Hi-Fi Products Service Bulletin

Model: MHC-450, HCD-H450/H450M

No. 449

Subject: Extension Cable Availability

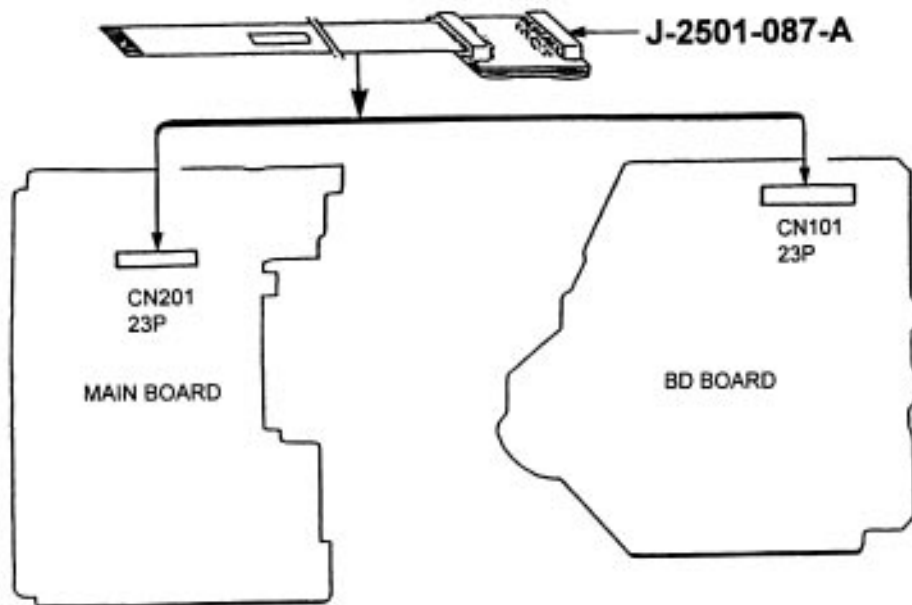
(**) Troubleshooting is difficult without an extension cable.

A 23p Extension cable is now available for servicing this unit while it is disassembled. The part number for the cable is J-2501-087-A. It is used to connect CN201 of the Main board to CN101 of the BD board. See diagram below.
